USH 12/29 (STOUT ROAD), CITY OF MENOMONIE:
PRELIMINARY PLAN LAYOUT (60%)
(FOR INTERNAL REVIEW ONLY)
OCTOBER 26, 2020

RRFB
RRFB
CURB RAMP PROPOSED TO BE RECONSTRUCTED TO MEET CURRENT ADA STANDARDS
CONTINUED FROM PAGE 1
CONTINUED ON PAGE 3
SHEET 2 OF 4

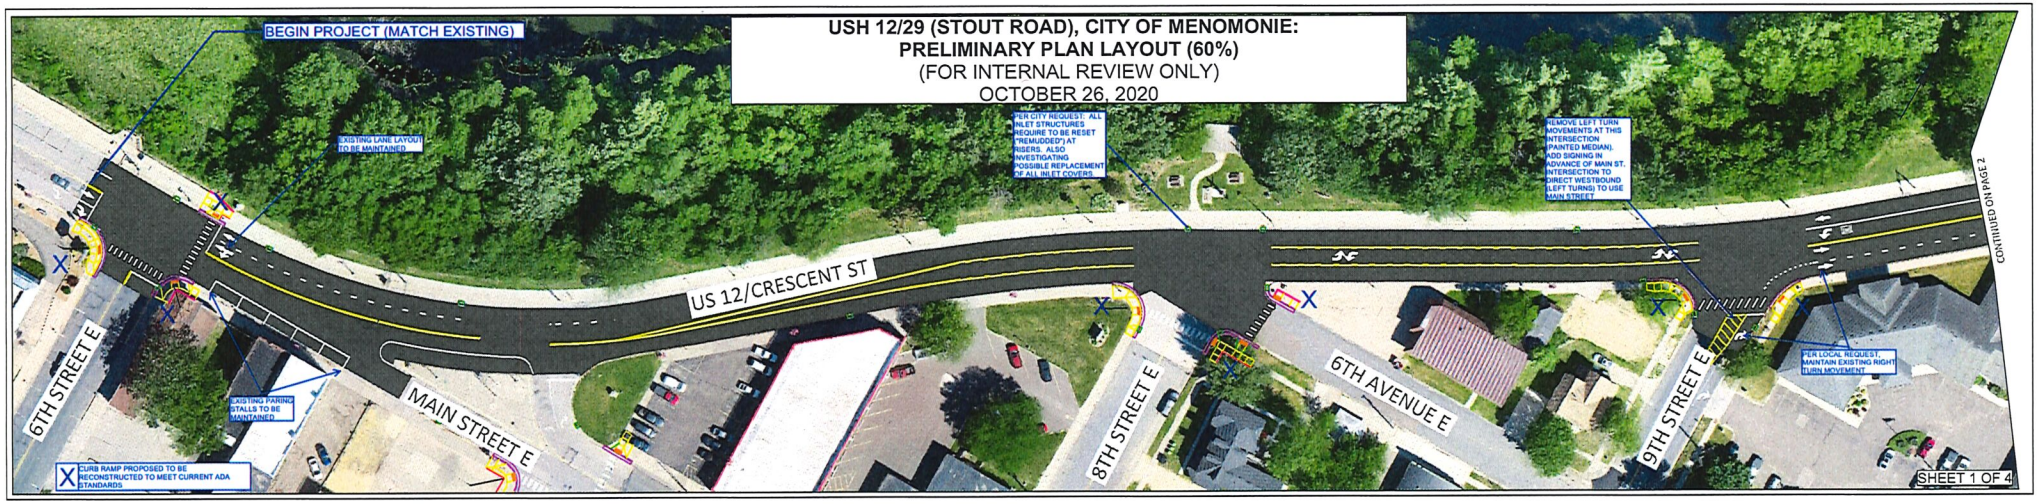
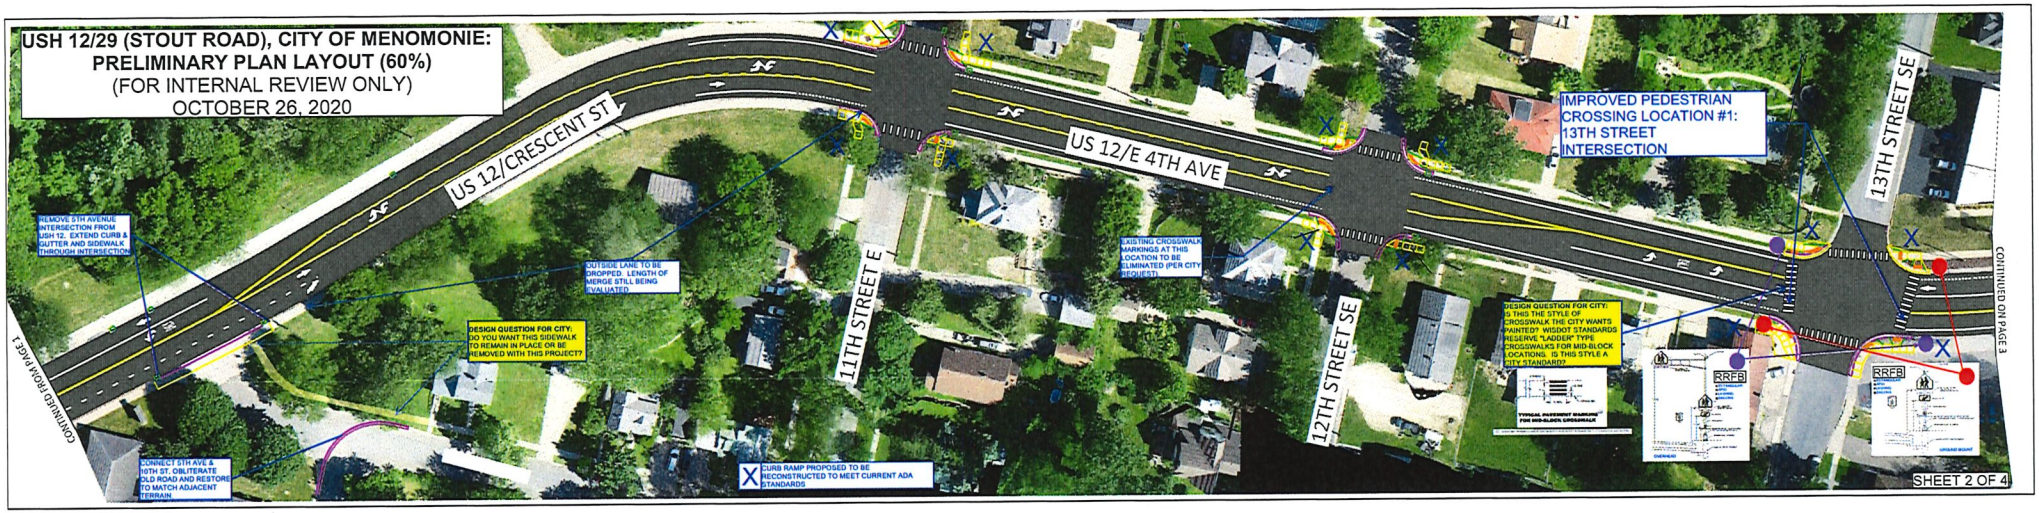
USH 12/29 (STOUT ROAD), CITY OF MENOMONIE:
PRELIMINARY PLAN LAYOUT (60%)
(FOR INTERNAL REVIEW ONLY)
OCTOBER 26, 2020
US 12/CRESCENT ST
US 12/E 4TH AVE
11TH STREET E
12TH STREET SE
13TH STREET SE
IMPROVED PEDESTRIAN CROSSING LOCATION #1: 13TH STREET INTERSECTION
REMOVE 5TH AVENUE INTERSECTION FROM USH 12. EXTEND CURB & GUTTER AND SIDEWALK THROUGH INTERSECTION.
OUTSIDE LANE TO BE DROPPED. LENGTH OF MERGE STILL BEING EVALUATED.
DESIGN QUESTION FOR CITY: DO YOU WANT THIS SIDEWALK TO REMAIN IN PLACE OR BE REMOVED WITH THIS PROJECT?
CONNECT 5TH AVE & 10TH ST. OBLITERATE OLD ROAD AND RESTORE TO MATCH ADJACENT TERRAIN
EXISTING CROSSWALK MARKINGS AT THIS LOCATION TO BE ELIMINATED (PER CITY REQUEST)
DESIGN QUESTION FOR CITY: IS THIS THE STYLE OF CROSSWALK THE CITY WANTS PAINTED? WISDOT STANDARDS RESERVE "LADDER" TYPE CROSSWALKS FOR MID-BLOCK LOCATIONS. IS THIS STYLE A CITY STANDARD?
TYPICAL PAVEMENT MARKING FOR MID-BLOCK CROSSWALK
